Product Change Notification / NTDO-14MNBI131

CCB 5025 Initial Notice: Qualification of G700 as a new mold compound material for selected Micrel MIC3490, MIC52xx, MIC62xxxM5, SPN020xxxx device families available in 5L SOT-23 package assembled at STAR assembly site.

Pre and Post Change Summary
PCN #: NTDO-14MNBI131

Pre Change

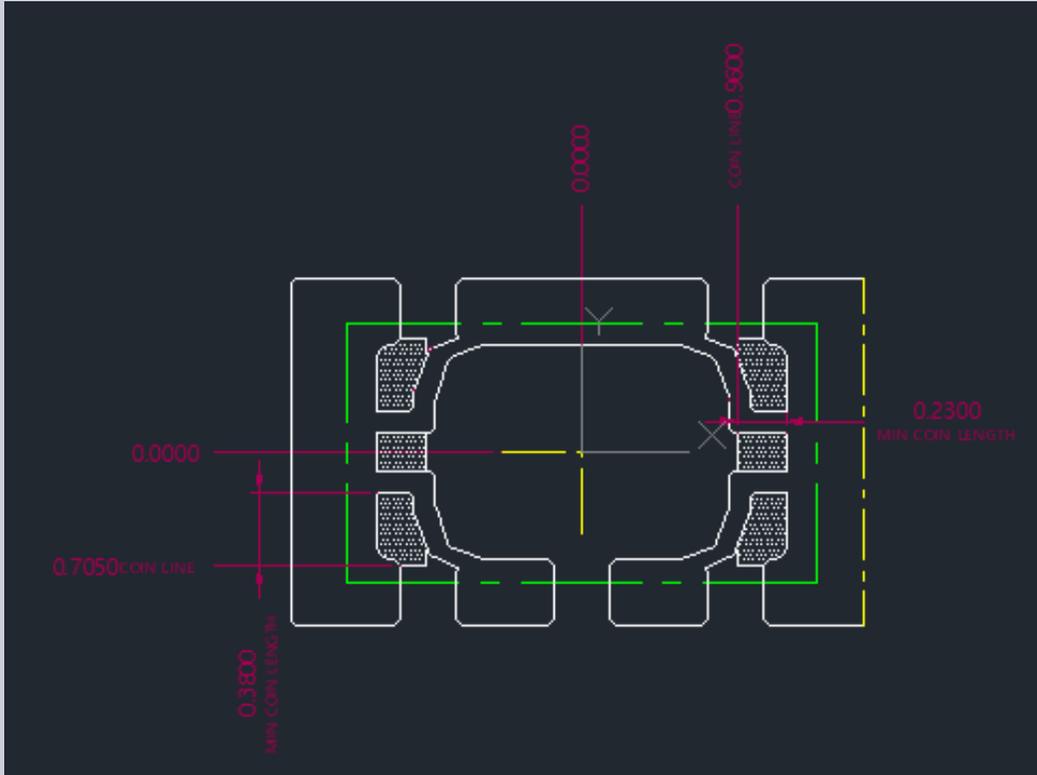
DAP Surface Prep	NiPdAu with Roughened
Lead-frame Material	C194

Post Change

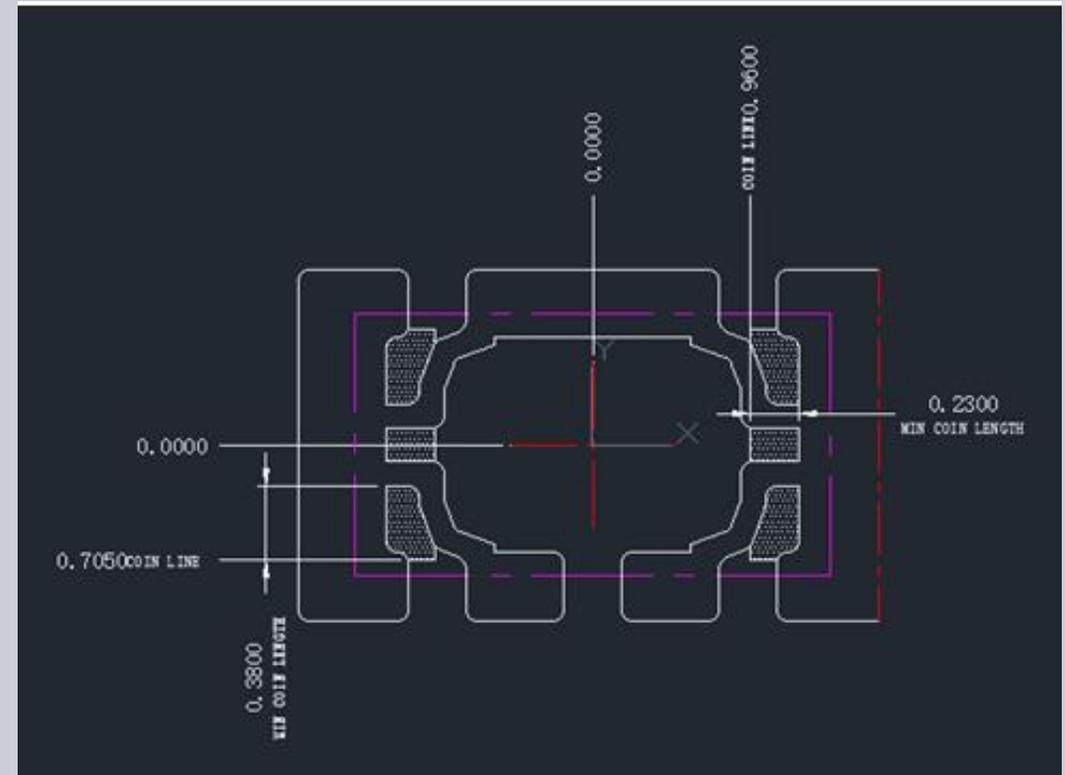
DAP Surface Prep	NiPdAu (Ag with Roughened)
Lead-frame Material	C194
